From: Campbell McLaren [<mailto:gpcmlaren@gmail.com>]
Sent: Thursday, December 29, 2016 11:38 AM
To: Monroe, Pamela
Cc: waltpalmer1@gmail.com; Barbara Meyer; Iacopino, Michael J
Subject: Re: proposed trespass by Northern Pass

To the NH Site Evaluation Committee, New Hampshire Department of Transportation and Northern Pass Transmission, LLC.

HDD 020 EXIT AREA WORK SPACE

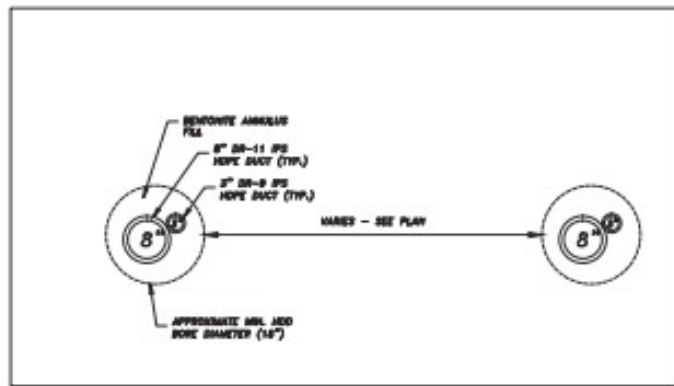
It has come to my attention that NPT, LLC is proposing a work area that encroaches on my property. The diagram below shows this work area in hatching. The existing pavement is indicated by wide dashed lines and is about 24" wide. The easement (R/W) width shown in this diagram is 4 rods (66') whereas the actual easement width is 40'.

In addition, the "open passage lane" encroaches on private land on the other side of the road. Where NPT LLC has drawn in this passing lane, there is a steep slope, stream and another steep slope.

This proposed travel lane also goes over a foundation hole and daylilies; further indication that this is private land.

DETAIL A - HDD 010 DUCT BUNDLE
SCALE: N.T.S.

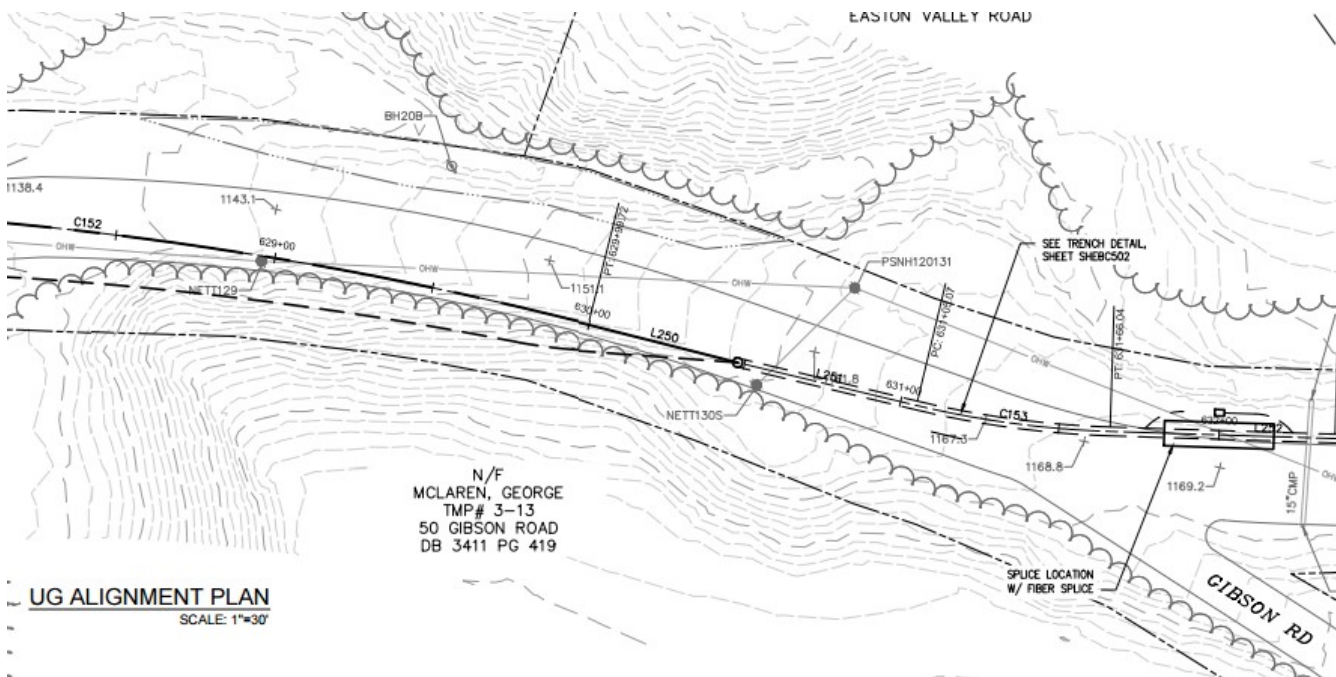
In addition, the planned HDD drilling and cable placement location is shown as on my property, and the diagram showing cables placed in two separate conduits for HDD begs the question of where the second line is planned to be located and why it is not shown in this diagram.

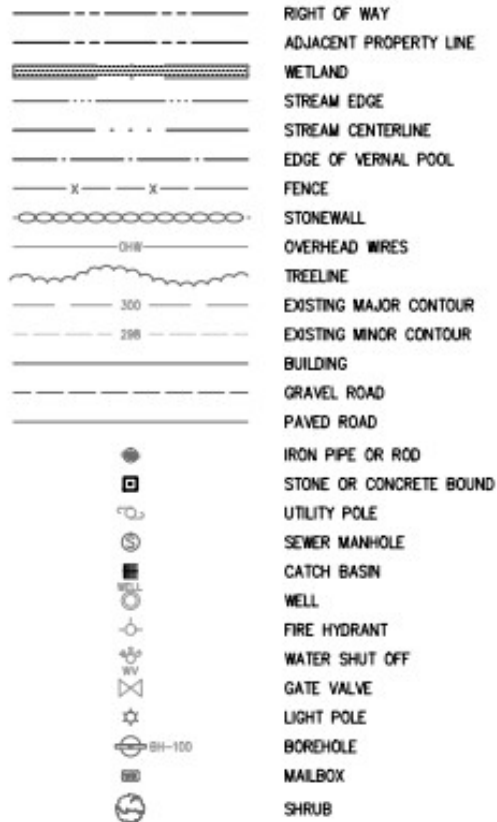
Light grey lines show existing pavement. Stream is not shown. Heavy grey dashed line is the proposed underground cable location. Notice that the splice vault is shown in two different places on the two diagrams. Notice also that the dot (above) and rectangle (first page) showing the HDD slurry pit do not show its true dimensions of 20' x 60' x 20'.

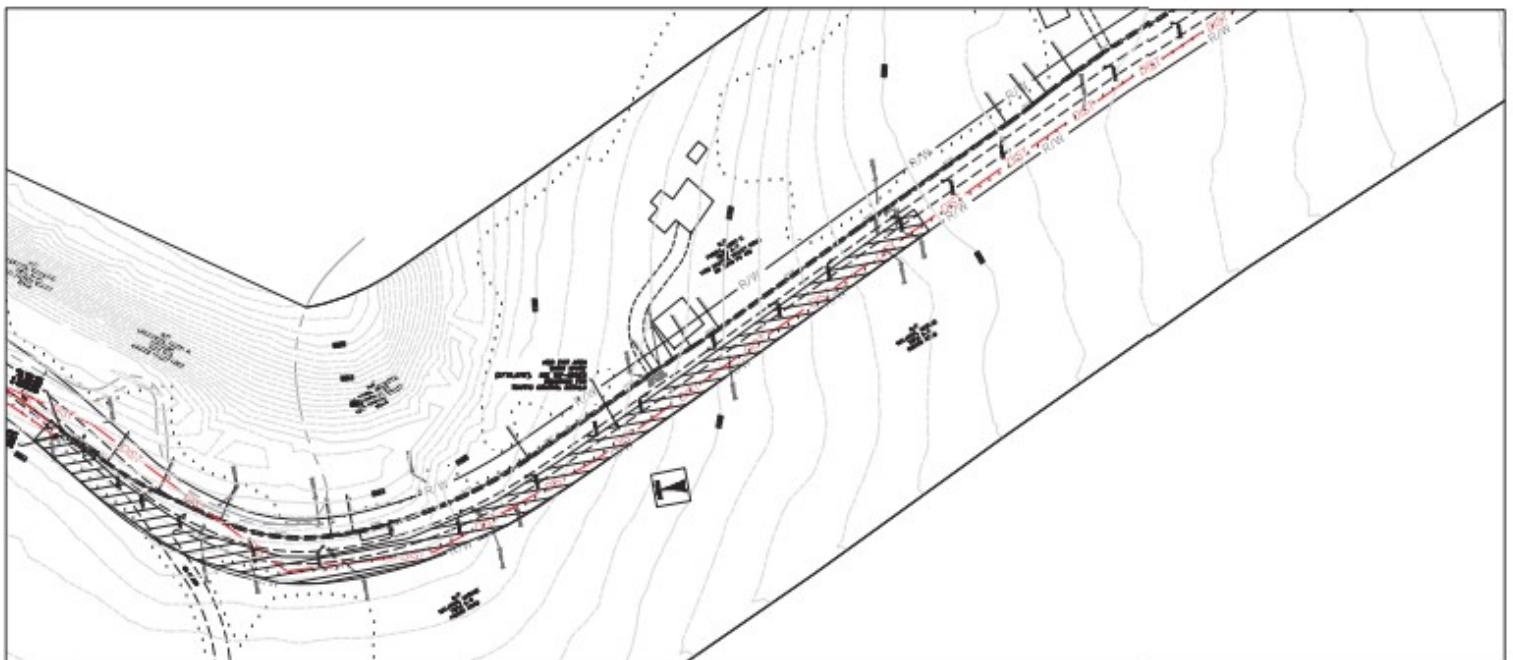
Unfortunately the legend has similar designations for 'right of way' and 'adjacent property line' and 'stream edge.' 'Gravel road' also looks very much like 'trench limits', and 'building' like 'paved road.' I am unable to find what the red DST line means.

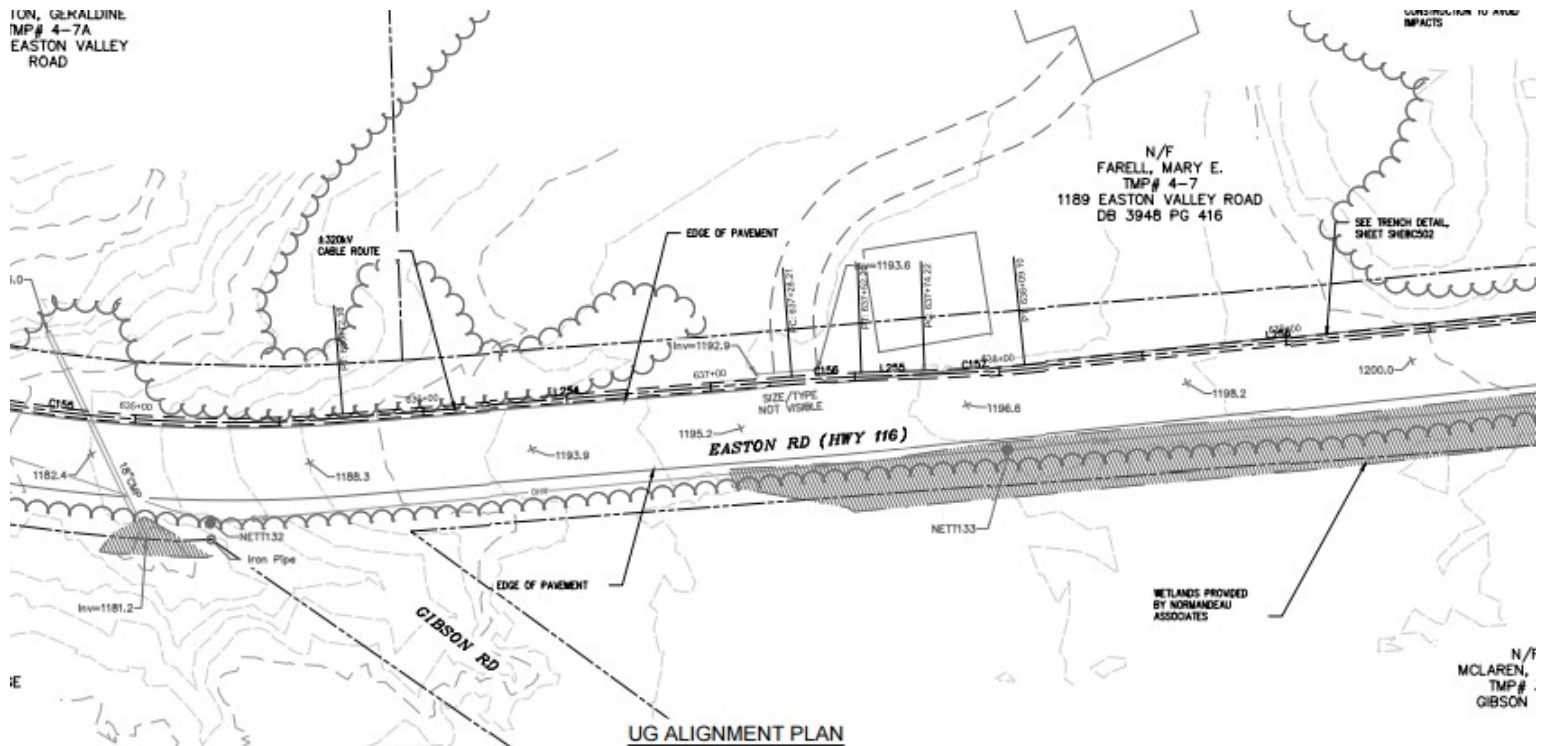
Work area map (above) and wetlands map (below) are separate, and the proposed work area is not only on my property, but on my wetlands, which of course continue beyond what is shown in the map.
